Subject: GETS Pre-Startup Monitoring Data Package Addendum  
Tyco FTC PFAS, 2700 Industrial Parkway South, Marinette, WI

This addendum has been prepared in response to comments received from Wisconsin Department of Natural Resources (WDNR) on August 24, 2022 and is being submitted in accordance with NR 724.13(3) and NR 724.17(3m).

TYCO FIRE TECHNOLOGY CENTER MARINETTE, WI <b>GETS PRE-STARTUP MONITORING DATA PACKAGE</b>	
<b>TRANSDUCER HYDROGRAPHS AND          DITCH B FLOW RATES</b>	
	FIGURE <b>4a</b>

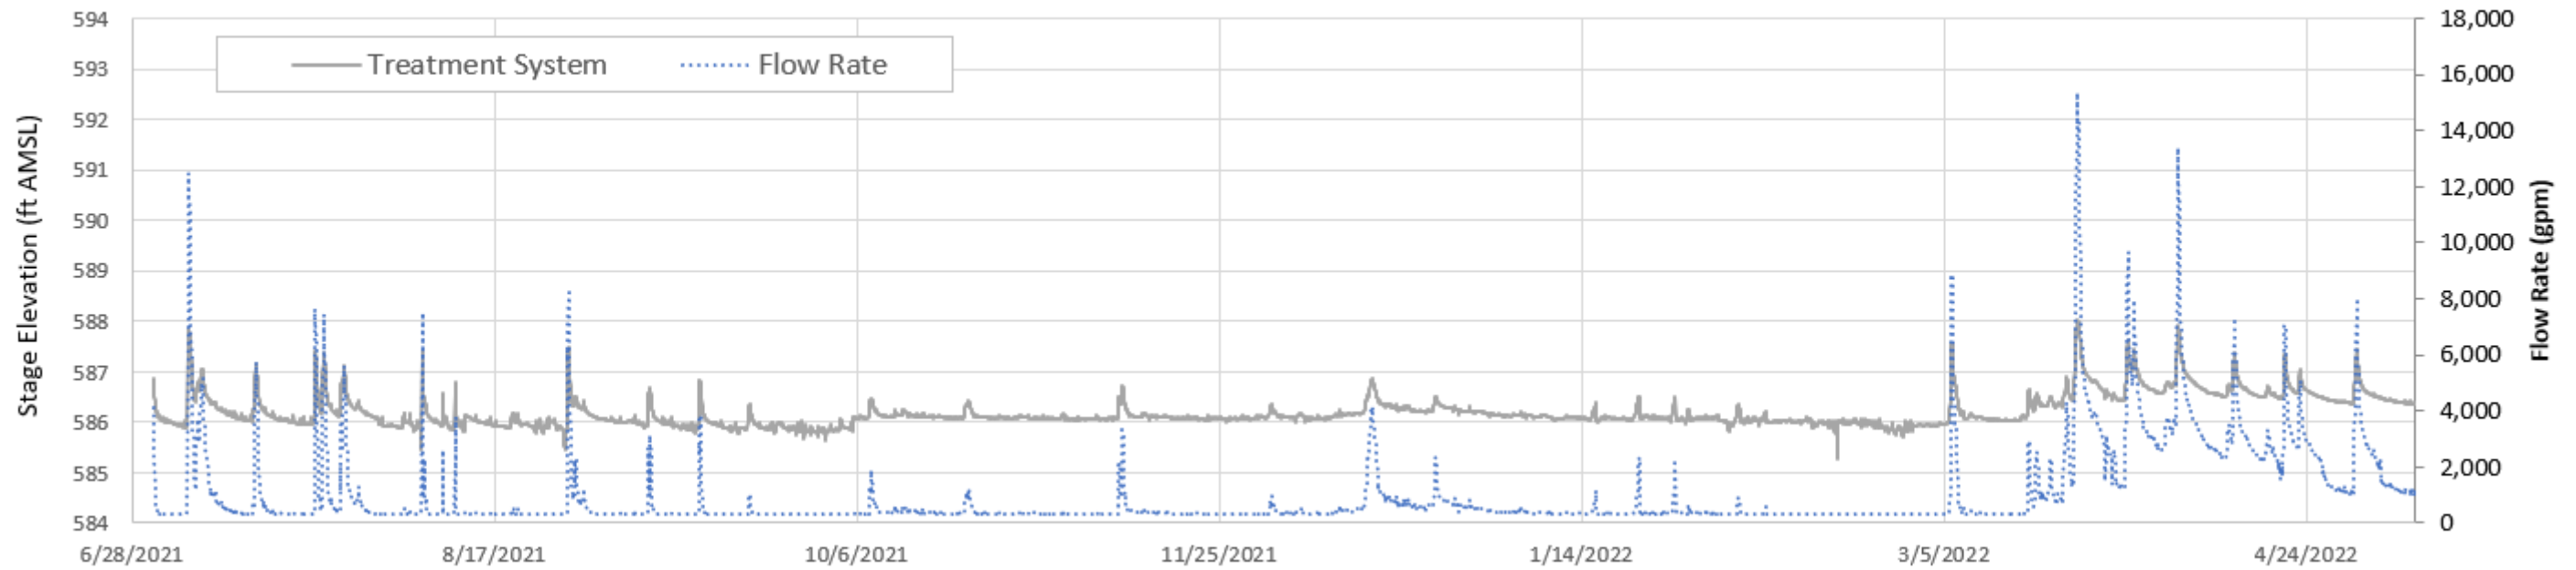
- WDNR Comment: The continuous pressure transducer data for Ditch B in Figure 4 is incomplete.

- WDNR Comment: Include the stage/elevation measured at the Ditch Treatment System where flow rate is determined.

*All transducer data collected through April 2022 were included within the original submittal July 15, 2022 and are provided in the attached addendum. No transducer data were collected at locations U10 and M09 during the winter months. The stilling wells and transducers were removed from the ditch on November 21, 2021 to prevent damage as a result of ice accumulation. In anticipation of GETS startup, the stilling wells were reinstalled and the transducers were placed back into the stilling*

wells at locations U10 and M09 in May 2022. Data collected after reinstallation will be provided in forthcoming startup phase reports.

For location M09, there are no transducer data from July 5 through July 14, 2021, as the transducer was knocked down due to debris in the ditch. The stilling well and transducer were reinstalled more securely on July 14 and data collection resumed.

*Transducer data from the Ditch B treatment system have been added to Figure 4. Note that transducer data at the Ditch B treatment system are provided beginning on July 1, 2021. The data prior to this date may be affected by the treatment system intake depressing the surface water elevation and thus may be biased low. The transducer location was moved upstream in July and then further upstream in October to minimize the impacts of the treatment system intake on stage/elevation measurements. Because of this uncertainty, the water elevations from SG-L09 prior to July 1, 2021 are not used to evaluate natural water elevation.*

TYCO FIRE TECHNOLOGY CENTER MARINETTE, WI <b>GETS PRE-STARTUP MONITORING DATA PACKAGE</b>	
<b>TRANSDUCER HYDROGRAPHS AND          DITCH B FLOW RATES</b>	
	FIGURE <b>4b</b>

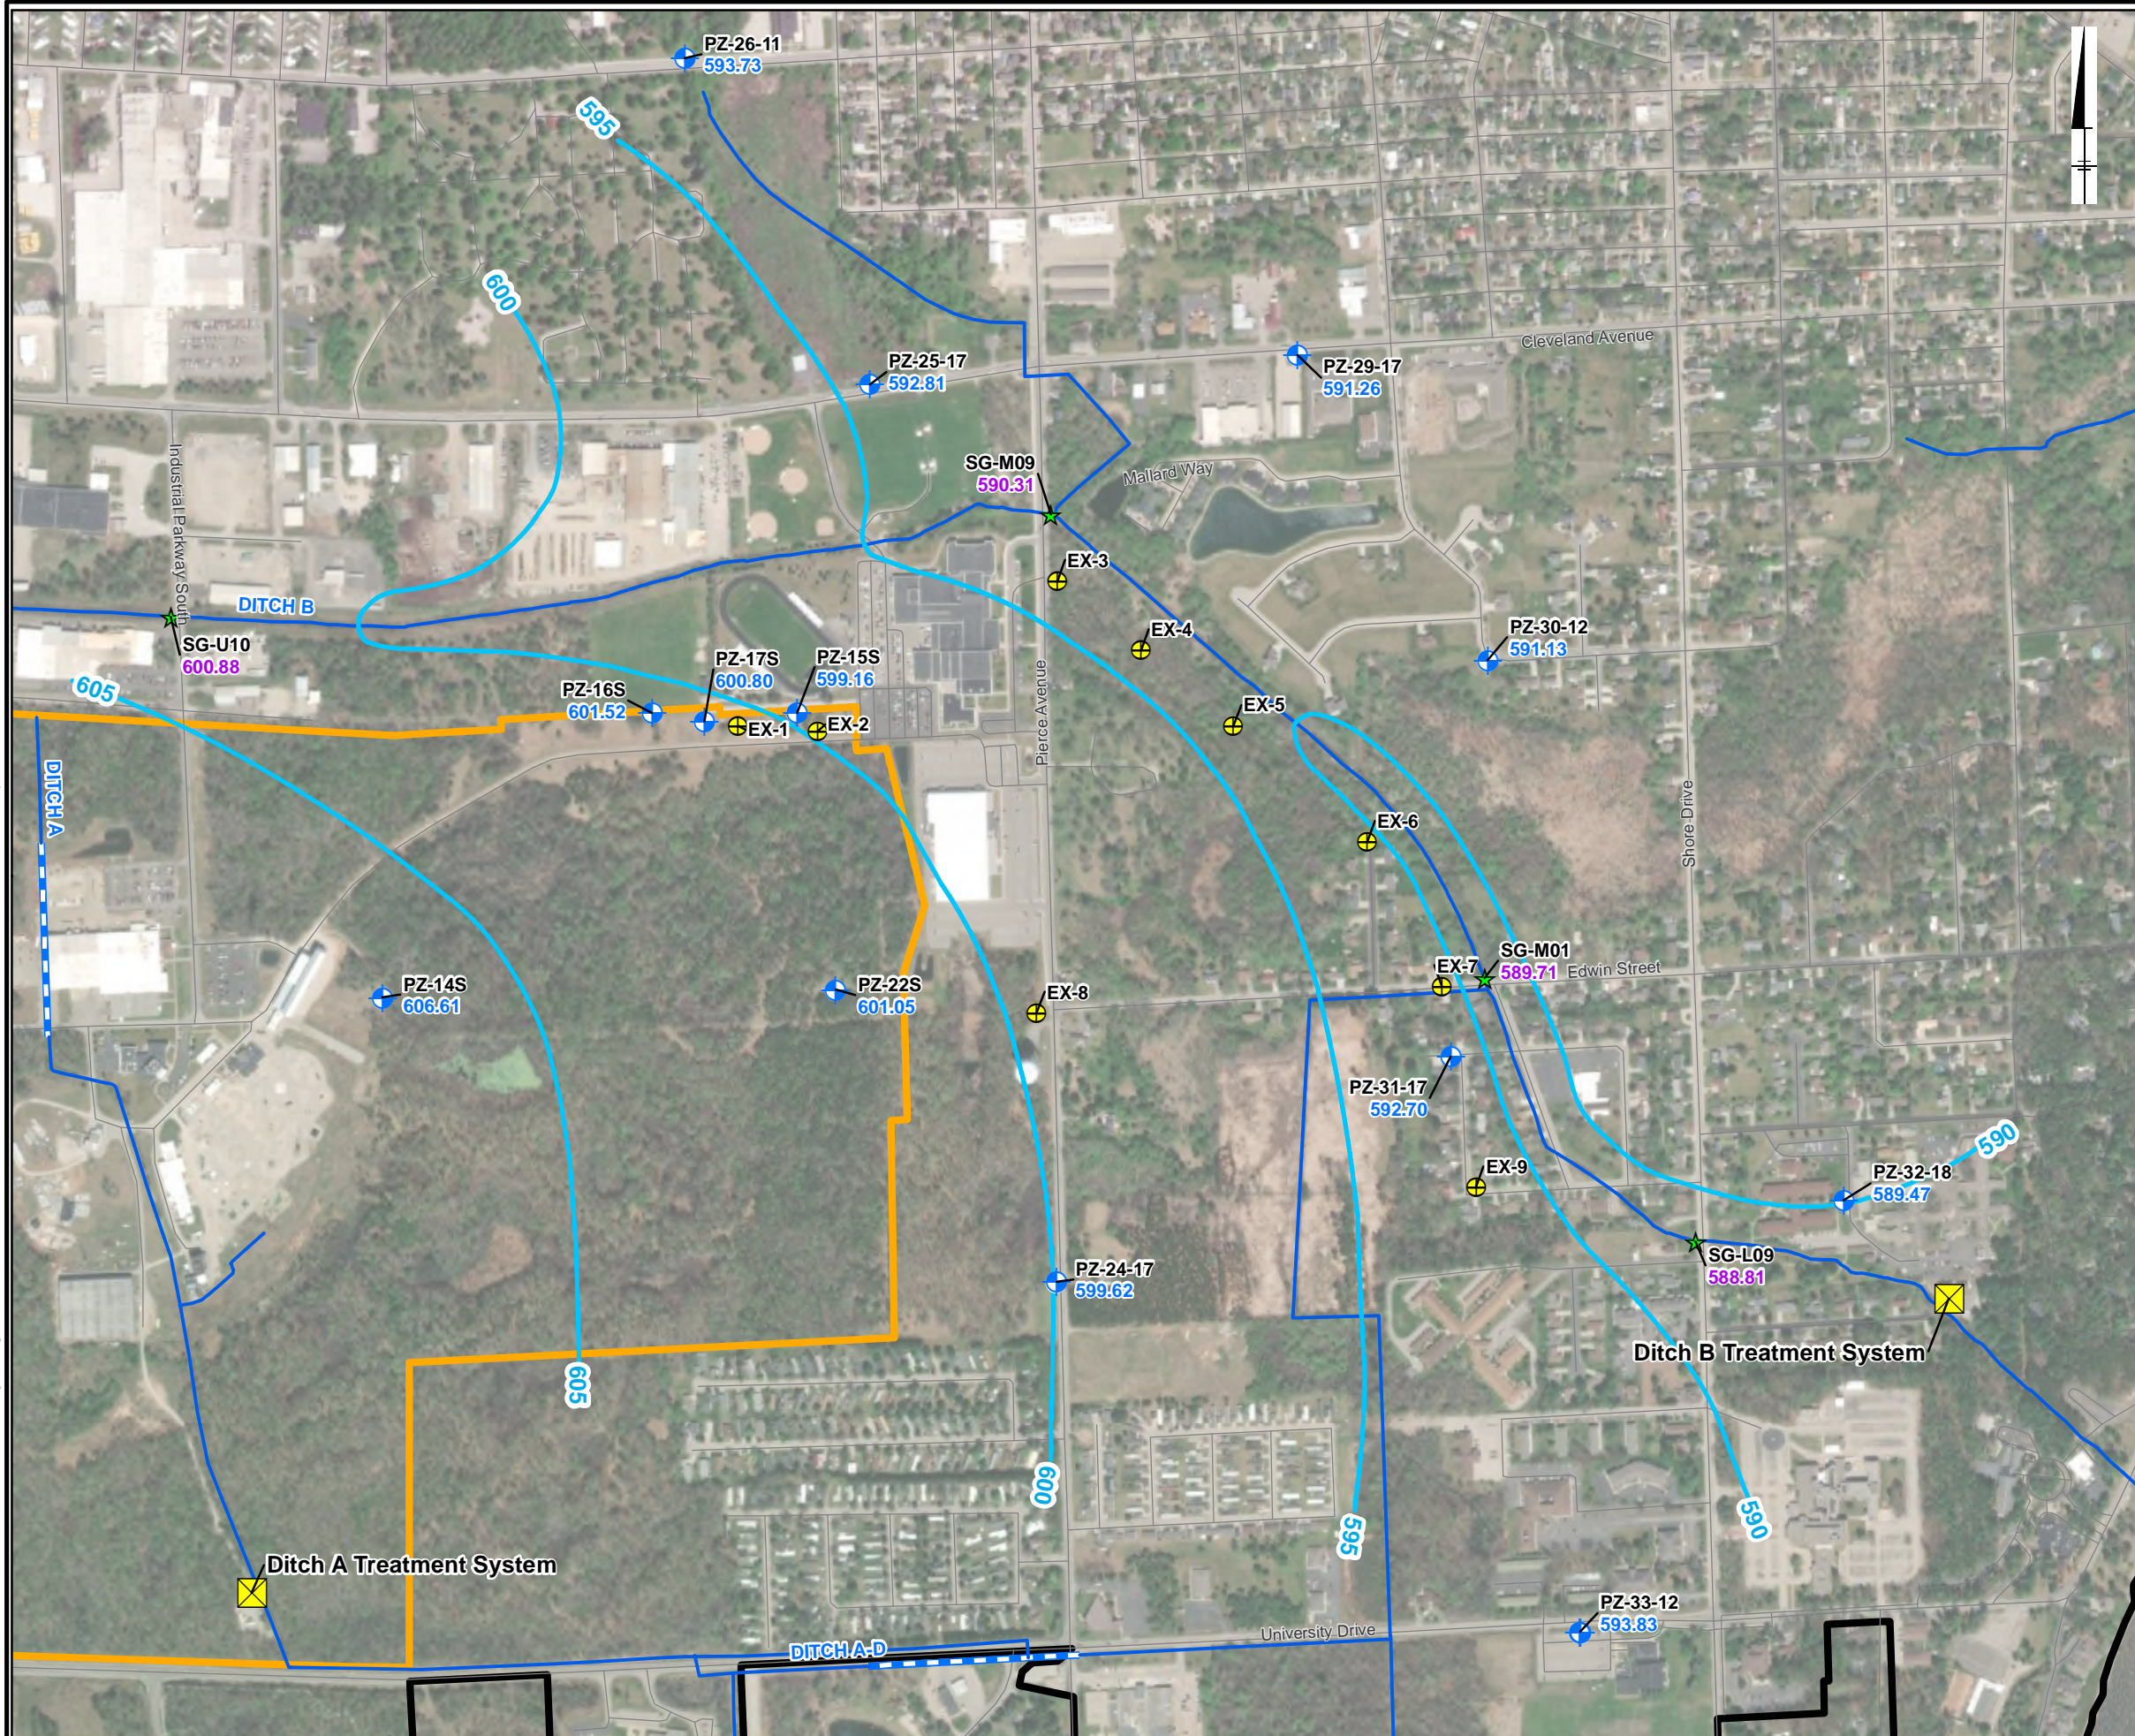
- WDNR Comment: Include a statement on how the transducer data are correlated to stage/elevation.

*The following statement has been added to the hydrograph figures: The data collected from each transducer provide the water depth at the transducer collected hourly. These data are then compared to manual measurements taken from the surveyed reference point and converted to a water level elevation.*
